REF: Notice of Deficiency – Tier II Permit Modification for Vertical Expansion, McAlester Army Ammunition Plant, New Landfill Pittsburg County, Solid Waste Permit #3561014

1. McAlester Army Ammunition Plant (MCAAP) has reviewed the comments presented by the Oklahoma Department of Environmental Quality (ODEQ) in the Notice of Deficiency (NOD) letter dated October 18, 2019. We have presented the original ODEQ comments below along with our responses. We hope you find the responses acceptable and that the changes reflected in the revised permit application address the concerns and noted deficiencies presented in the NOD letter to ODEQ's satisfaction.

**Corrected Final
RCRA-D Permit Modification Application for
the Non-Hazardous Industrial Waste Landfill
McAlester Army Ammunition Plant
McAlester, Pittsburg County, Oklahoma 74501**

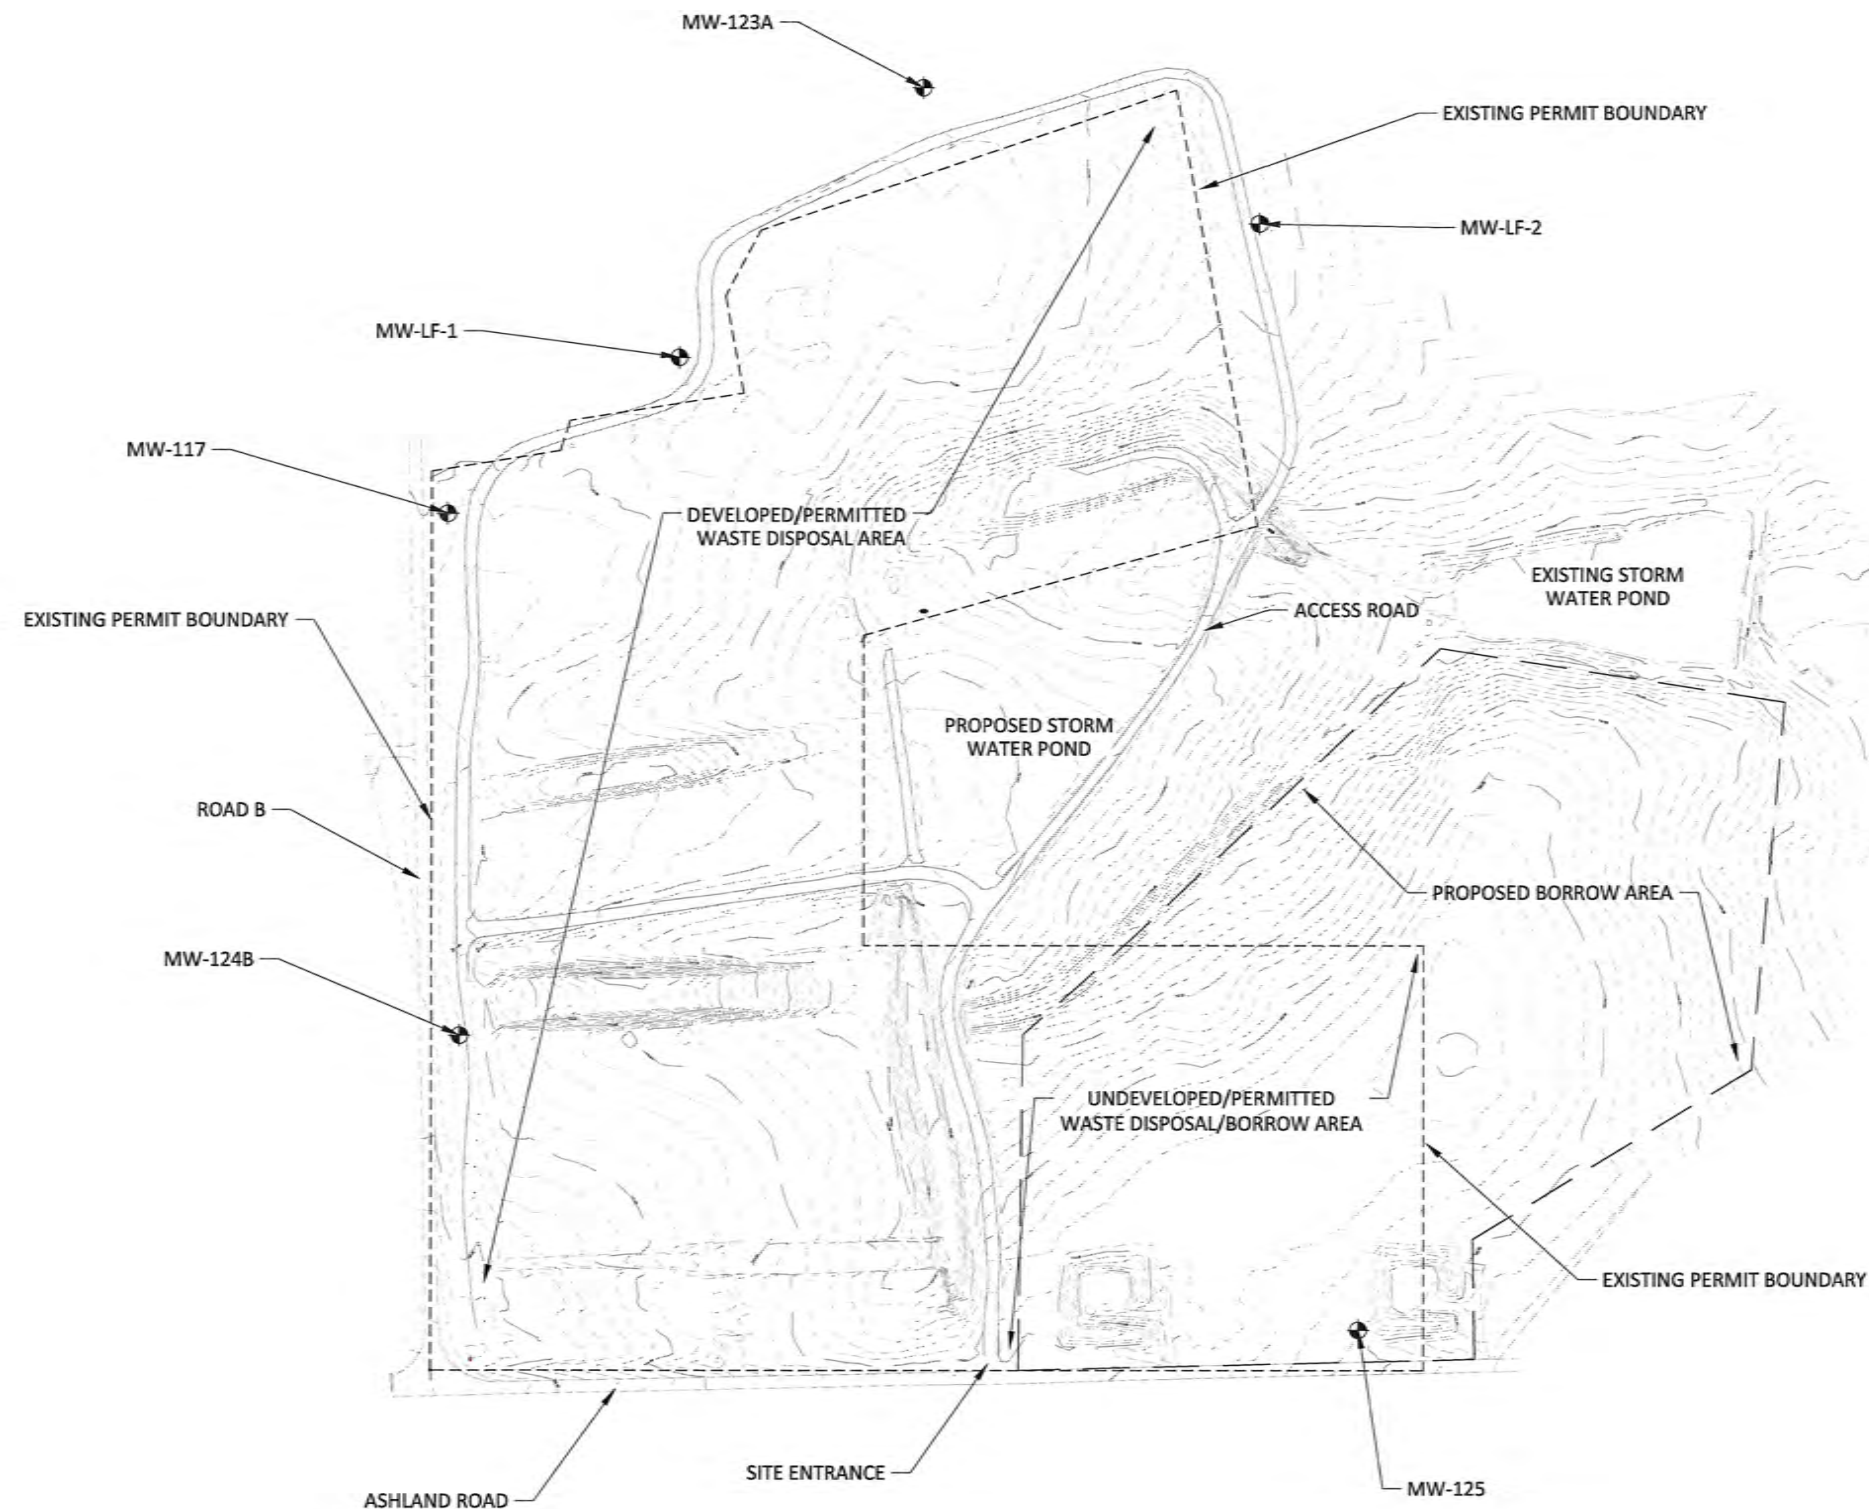
Question. The Application includes a proposed expansion of the permit boundary, but no expansions of the waste boundary are proposed. Oklahoma Administrative Code (OAC) 252:515-1-31 and 51 include restrictions on the location of permit boundaries that were not addresses in the Application. Please provide demonstrations that the proposed permit boundary meets these requirements. Alternatively, MCAAP may reduce the permit boundary to the currently approved state and provide revised drawings and legal description.

Answer. MCAAP has decided to return to the originally approved landfill permit boundary. All figures and design drawing have been updated to show the original permit boundary and a copy of the original legal description has been incorporated into the revised permit application package.

REVISIONS				
No.	DATE	DESCRIPTION	DRAWN	CHKD
1	11/6/2019	REMOVED PERMIT EXPANSION BOUNDARY	MD	GJJ

FINAL COVER TYPICAL DETAIL
SCALE: N.T.S.

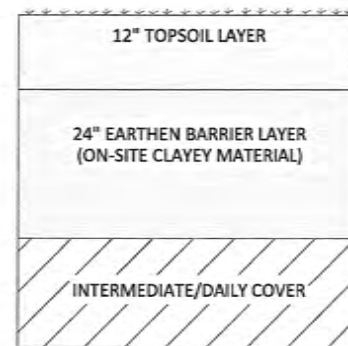
Question. The Application proposes final cover consisting of 2.5 feet of compacted clay overlain by 6 inches of topsoil. In accordance with OAC 252:515-19-53(a), the erosion layer must consist of at least 12 inches of soil capable of sustaining plant growth. Alternatively, per OAC 252:515-19-53(c), DEQ may approve the use of an alternative final cover design upon demonstration the alternative provides protection equivalent to the prescriptive design. Please either correct this specification in the Application or provide a demonstration that the proposed design provides equivalent protection.

Answer. The proposed final cover has been revised to consist of a compacted clay layer of 2.0 feet and soil suitable for sustaining vegetative growth to 12 inches. The design drawings have been revised to incorporate this change.

REVISIONS				
No.	DATE	DESCRIPTION	DRAWN	CHKD
1	11/2/2019	FINAL COVER TYPICAL DETAIL UPDATED	MD	GU
